10 March 2025

**CHANGE APPLICATION TO PDA DEVELOPMENT APPROVAL FOR PRECINCT
15 (PART) OF AURA AT LOT 10 BELLS CREEK ROAD, BANYA (EDQ
REFERENCE: DEV2023/1445)**

The proposal seeks approval for minor changes which are in response to construction and detailed design requirements. This includes amendments to the staging and Stormwater Bio Basins as well as various other minor and incidental changes.

Figure 4 – Car Parks

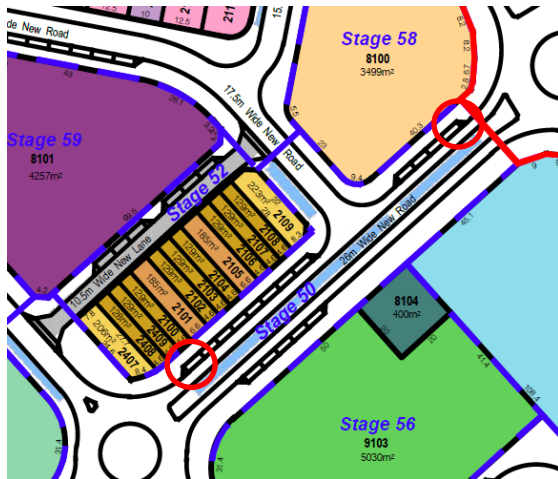
The end car park adjacent Lot 2409 and 2100 will be removed and relocated on the opposite verge to optimise space utilisation and improve traffic flow. The northern end car park adjacent Lot 8100 has been removed and will not be replaced. The new parking design will consider factors such as proximity to key amenities, ease of access, and safety, ensuring that the car parks are ultimately both functional and convenient. This is shown in **Figure 4** below.

Figure 5 – Billboard lot

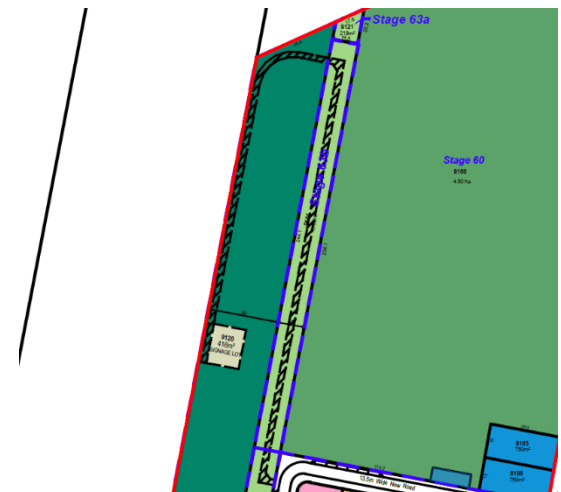
As the intention is for the acoustic mound to be eventually transferred to Council, a new 416m² lot (9120) will be created for the existing billboard on the Acoustic Mound and will remain in ownership of Stockland. Therefore, Council access for landscaping maintenance purposes will be facilitated through a reciprocal access easement which will exist in perpetuity. This is shown in **Figure 5** below.

Figure 6 – Neighbourhood Centre Access

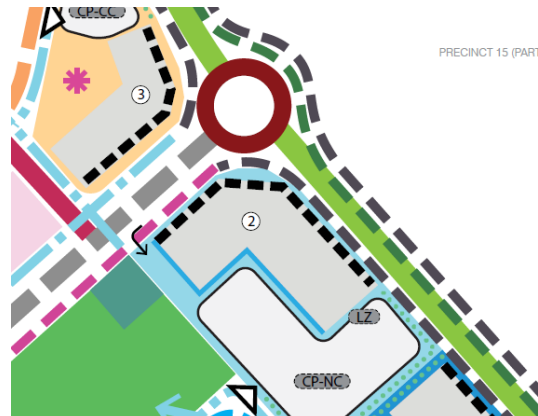
A left-in only access point from the Neighbourhood Connector will be implemented for the neighbourhood centre site (lot 8102) at the northern boundary. As a result of this change, traffic will be

directed out the centre through the urban village. This traffic management measure will help control ingress and egress, reducing congestion and improving safety for both vehicles and pedestrians. This revised access is shown in **Figure 6** below.

Figure 8 – Lot 9104 – Linear Park

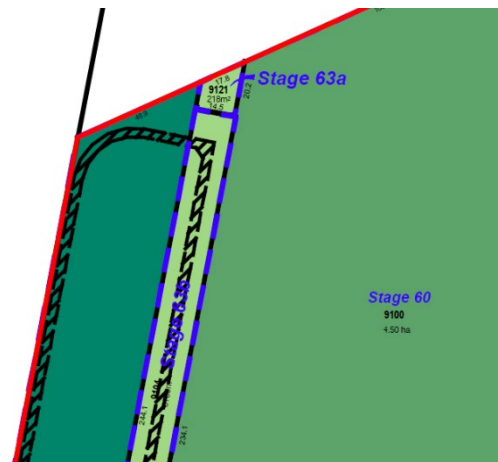
The width of the linear park (lot 9104) will be reduced to 15m where possible and where adjacent to the sports park. This adjustment will help offset potential PMT locations, ensuring the park remains functional and accessible while accommodating necessary infrastructure. A new lot has also been

created (lot 9121) at the northern end of the linear park where achieving a minimum width of 15m is not possible. This will ensure the bulk of the linear park (lot 9104) will remain creditable. While this small lot will not technically be considered a District Linear Park given it does not achieve a 15m minimum width, it will look and feel like a continuous linear park in this location and have no impact on the function of facilitating access through this portion of the site. This is particularly relevant noting it adjoins the District Sports Park and the delineation between these lots will be indistinguishable. The introduction of this lot is simply to ensure that minimum lot sizes can be achieved for the Sports Park once the PMT is installed. These changes are shown in **Figure 8** below.

Figure 9 – Laneway Position

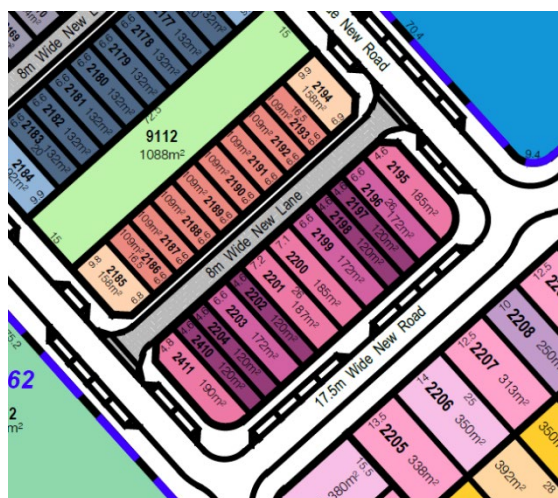
The lane will be shifted closer to lots 2195-2204 to facilitate servicing to lots 2185-2194. The new lane alignment will be designed to minimise disruption to residents while providing adequate space for service operations. This alignment is shown in **Figure 9** below.
